ADDENDUM

ADDENDUM No. 3	GMCa JOB #: 202113 TDH
ISSUE DATE: 04.22.24	SBC #: 364/011-05-2021
PROJECT: Tennessee Tech University Derryberry Hall – Building Upgrades – Phase I	1 William L. Jones Drive Cookeville, TN 38505
OWNER: Tennessee Tech University	1 Bridgestone Park, 3 rd Floor Nashville, TN 37214
ARCHITECT: Gilbert McLaughlin Casella architects	2305 Kline Ave, Suite 200 Nashville, TN 37211

ELECTRICAL LIGHTING PLAN - LEVEL 2
 SCALE: 1/8"=1'-0"

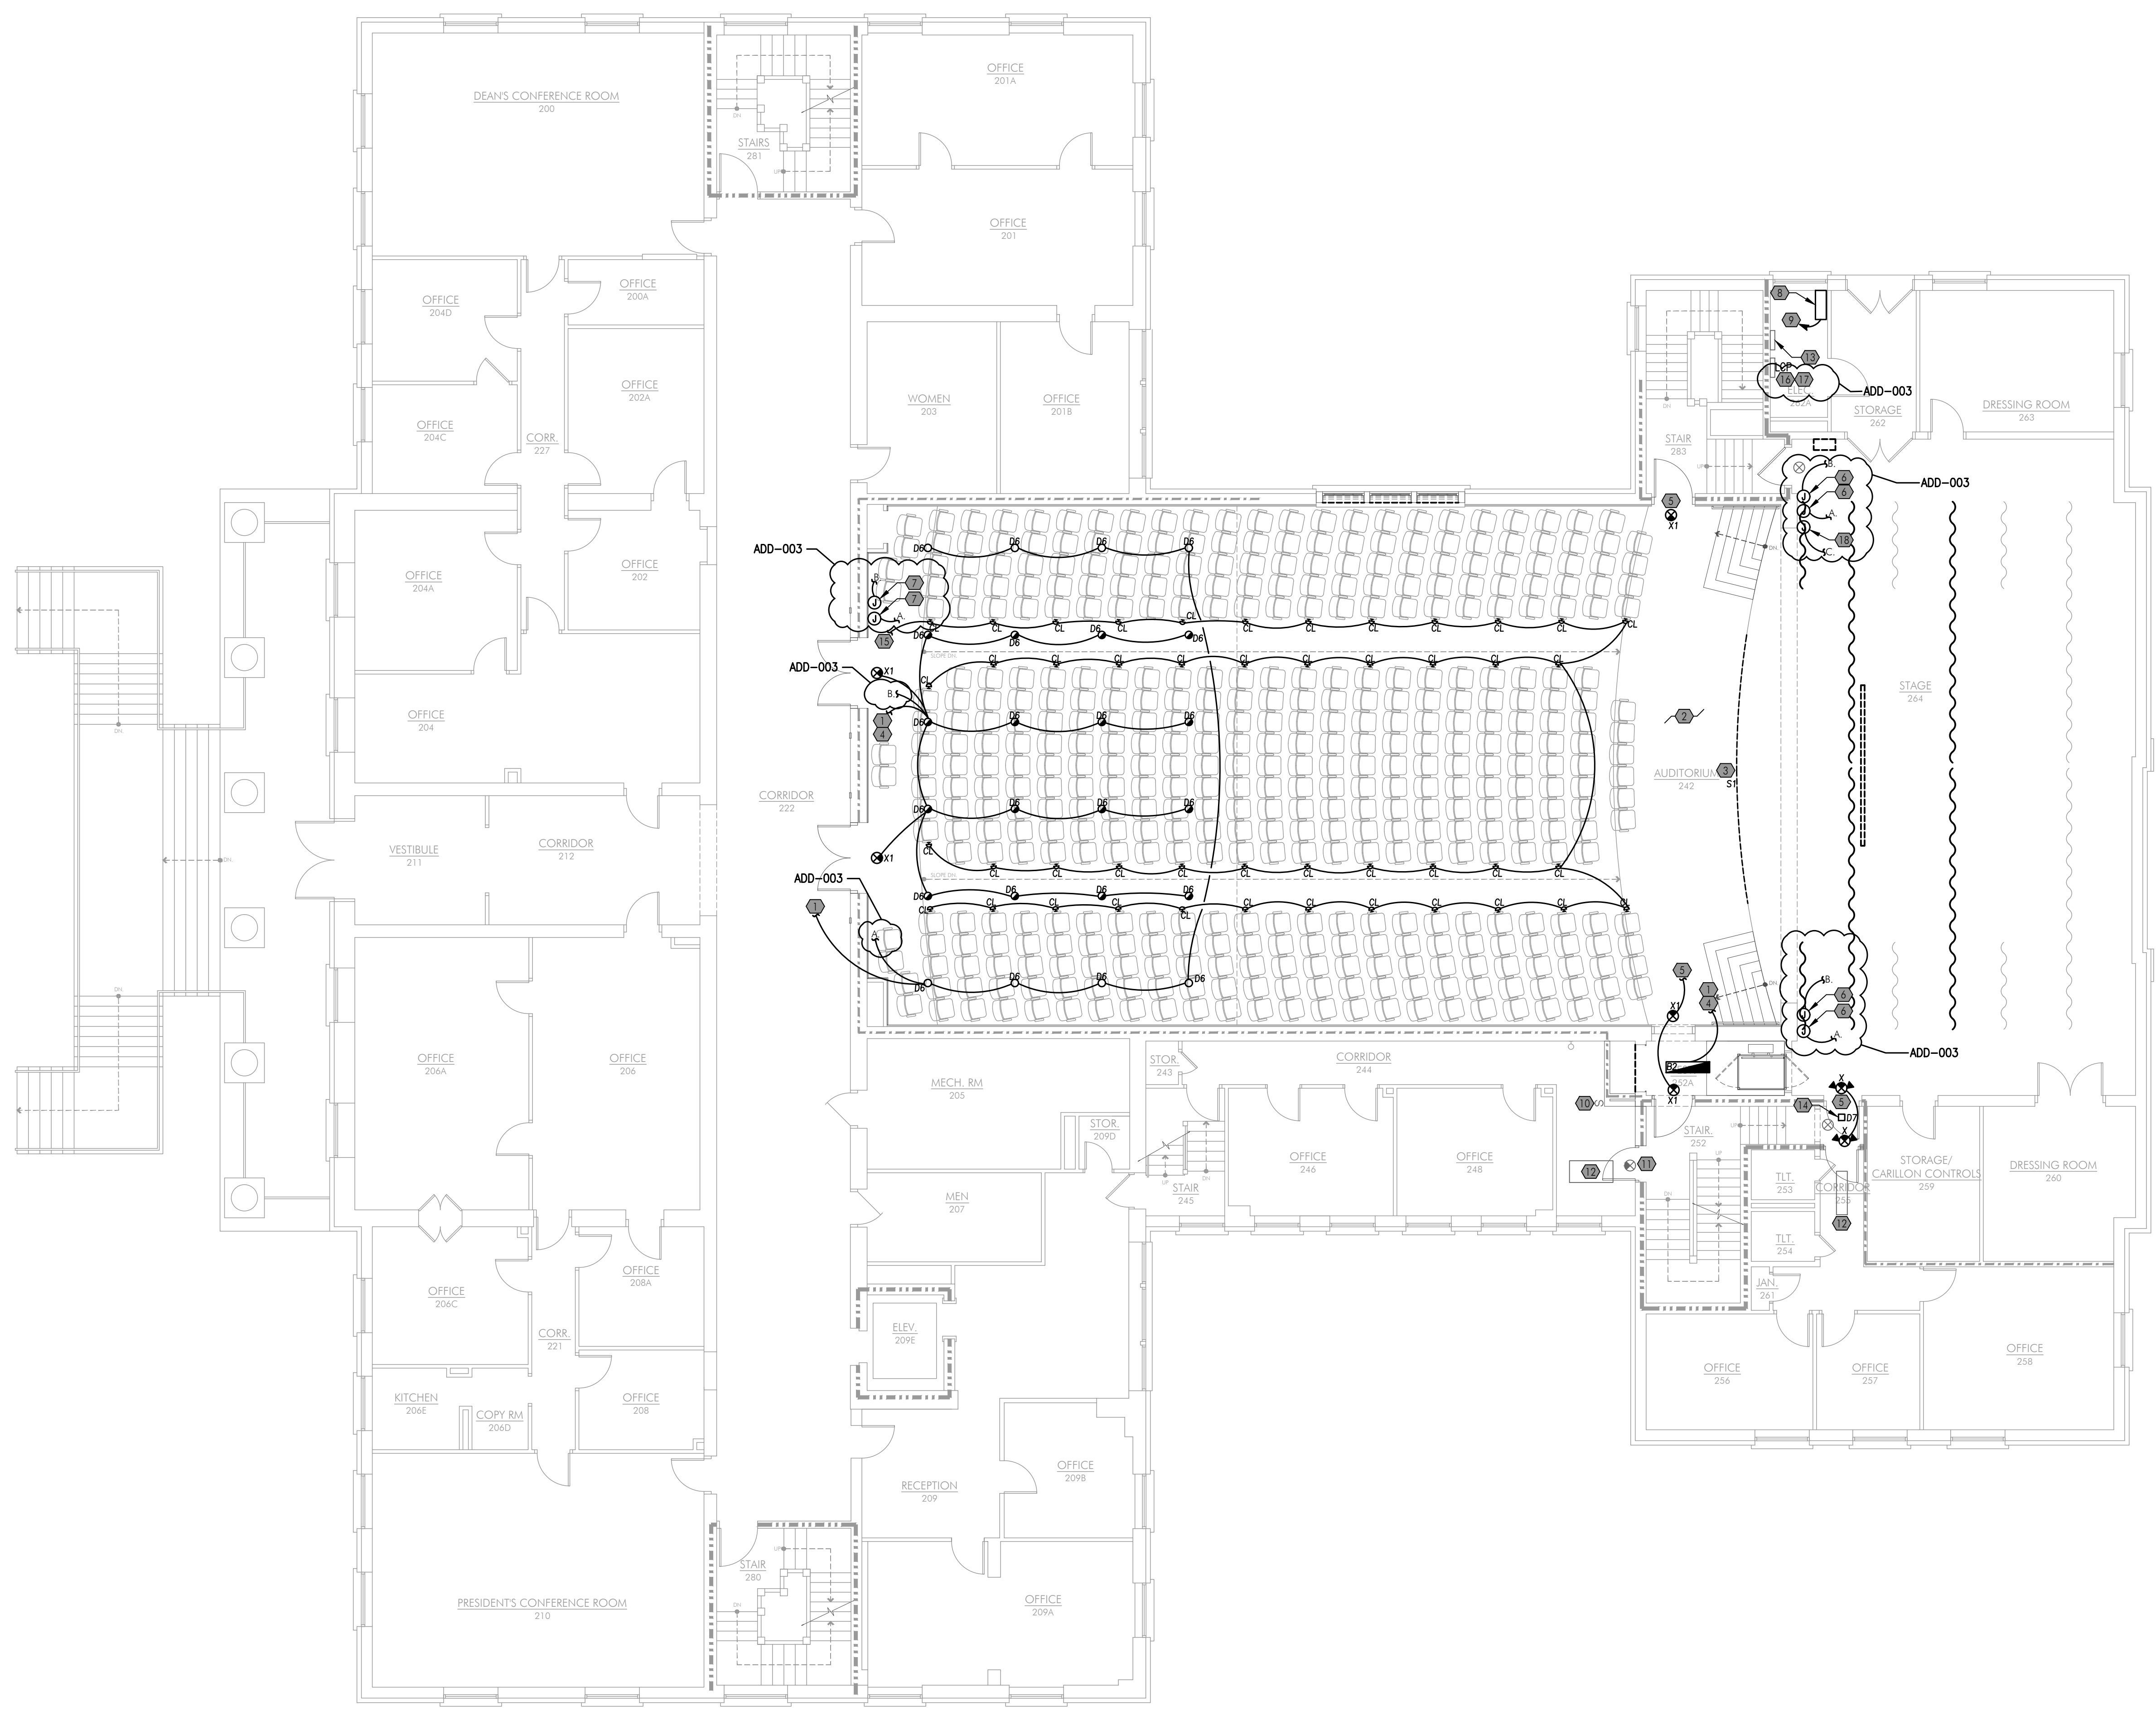
- a) **Per SFM’s Comments:** 4 detail marker references corrected
- 4) E2.2 - Electrical Lighting Plan - Level 2
 - a) **Per SFM Comments:** Added General Note E to call out required duration of emergency power systems.

- b) Updated Keyed Note 7 to call out Lutron Entry Station switch specifications.
 - c) Added Keyed Note 16, 17, & 18 for clarification regarding lighting control system.

1 ELECTRICAL LIGHTING PLAN - LEVEL 3
SCALE: 1/8"=1'-0"

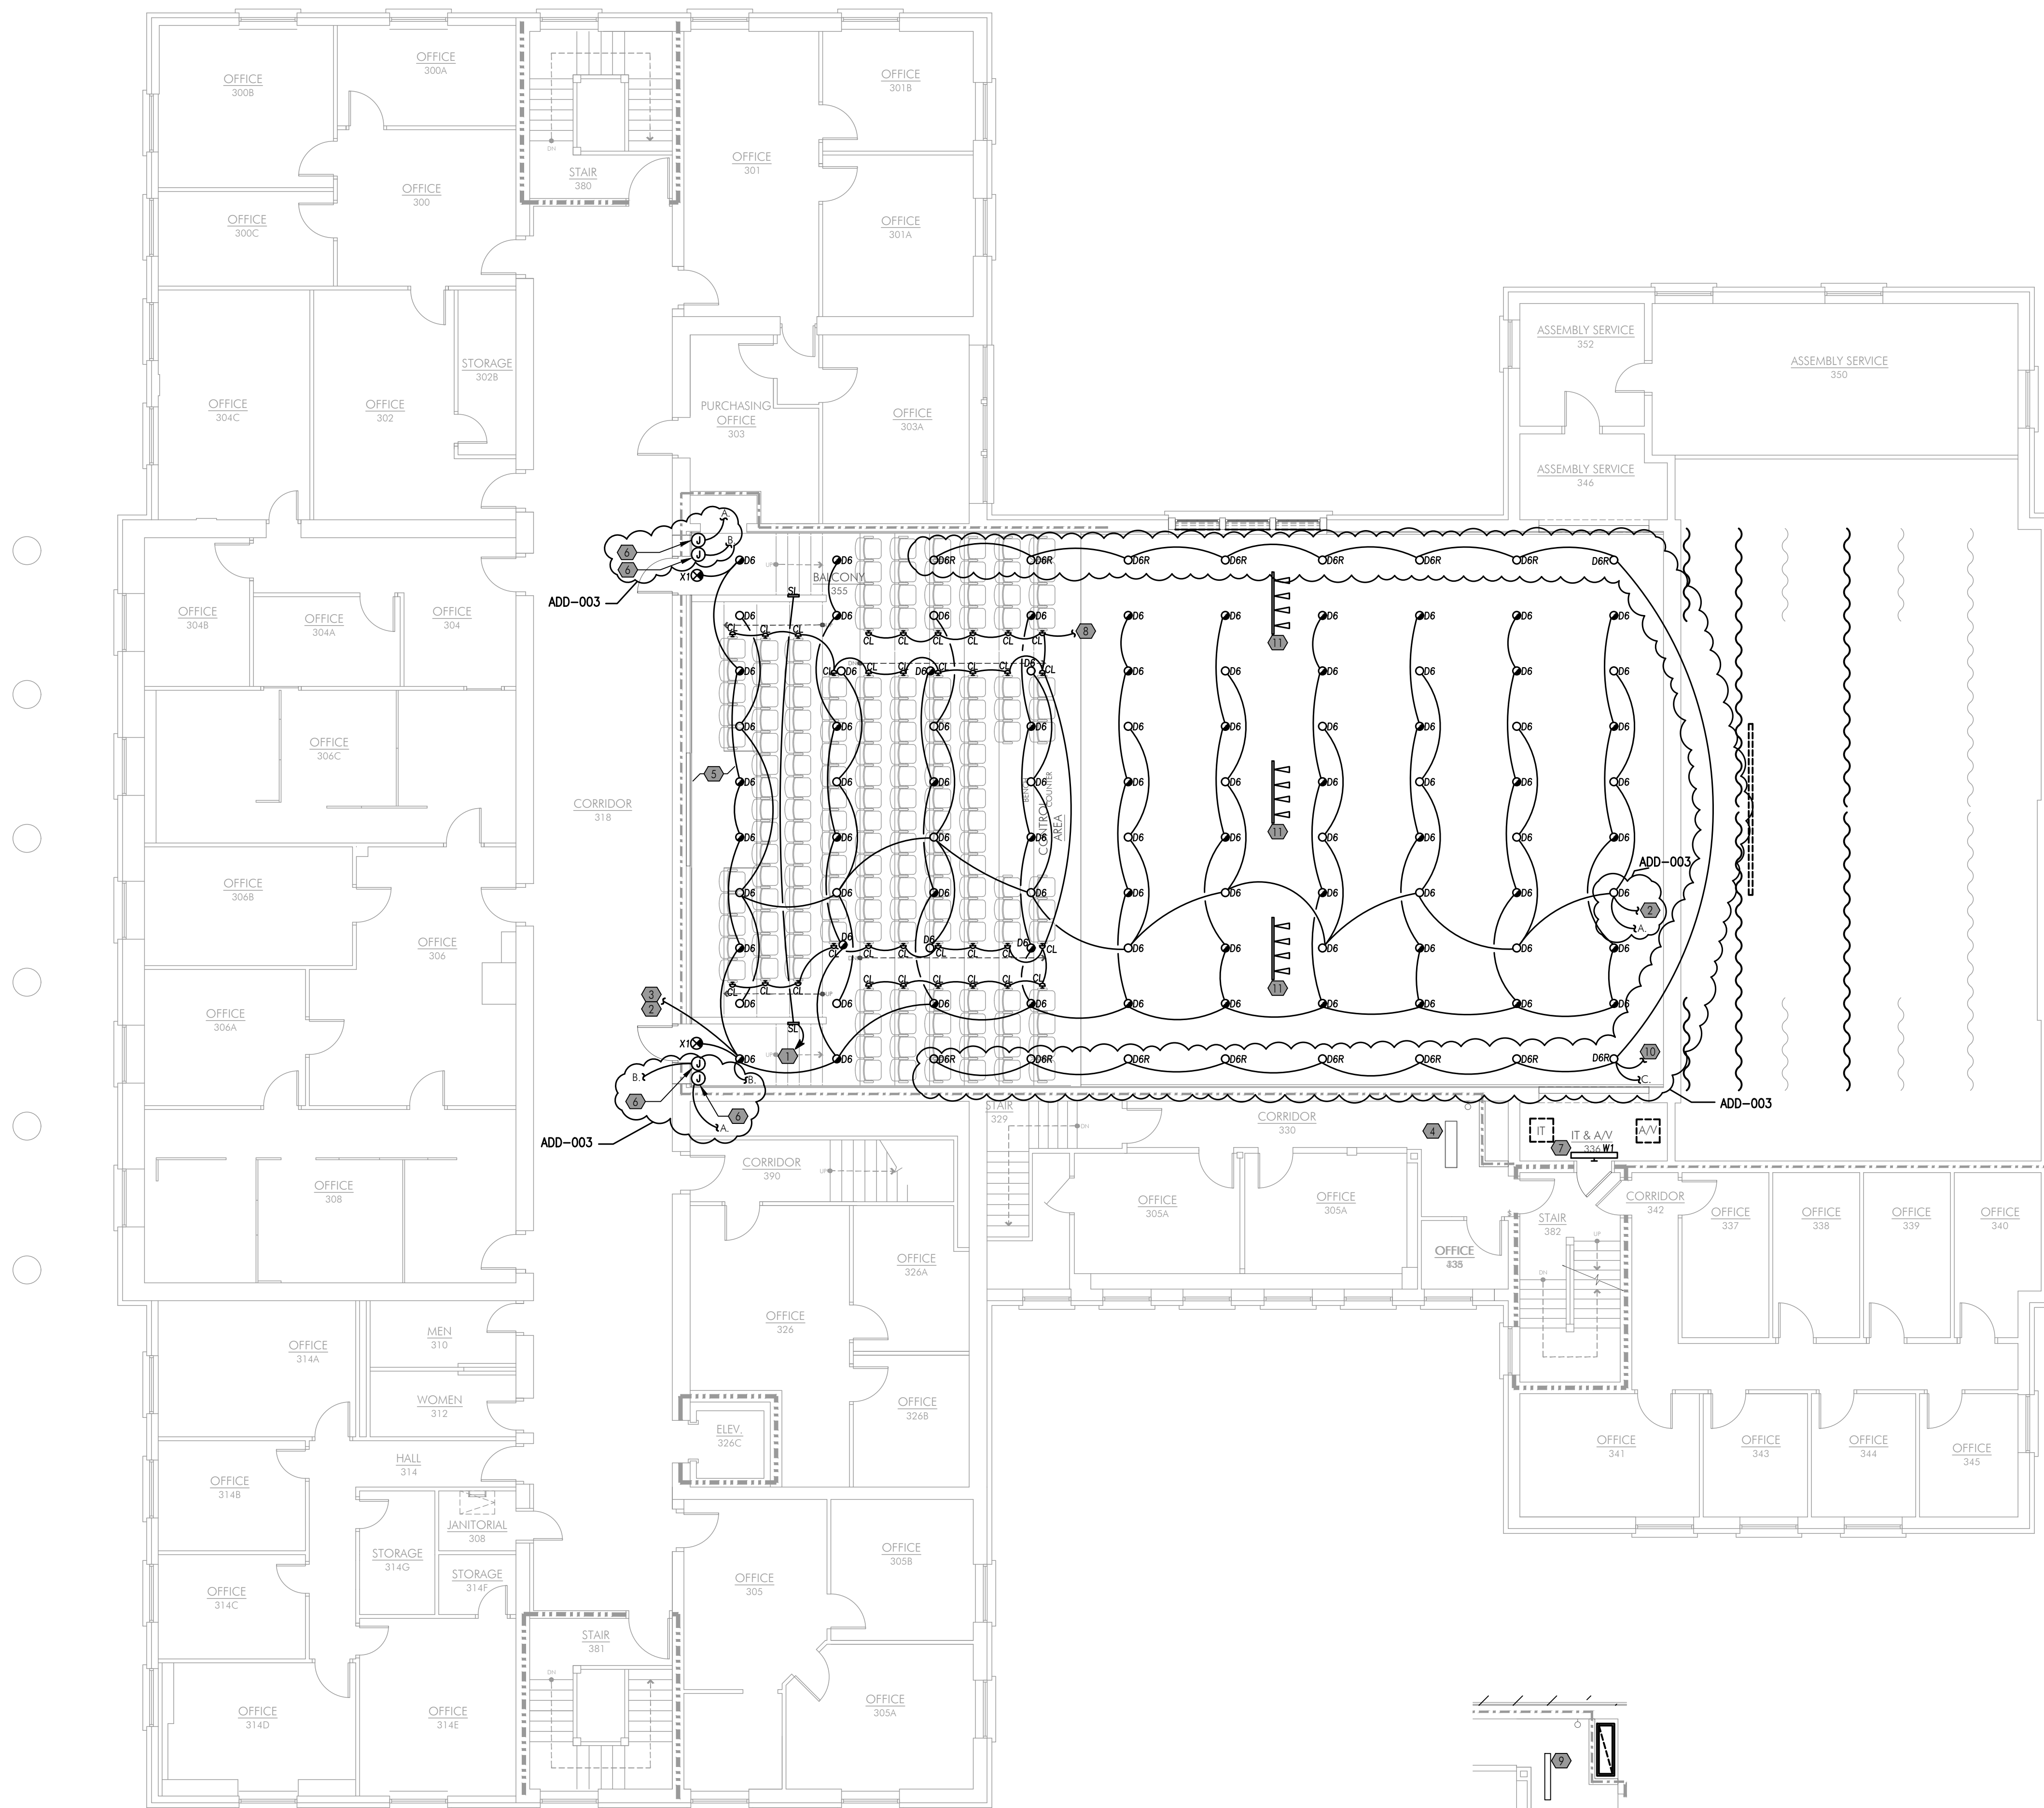
- 5) E2.3 - Electrical Lighting Plan - Level 3
 - a) **Per SFM Comments:** Added General Note E to call out required duration of emergency power systems.
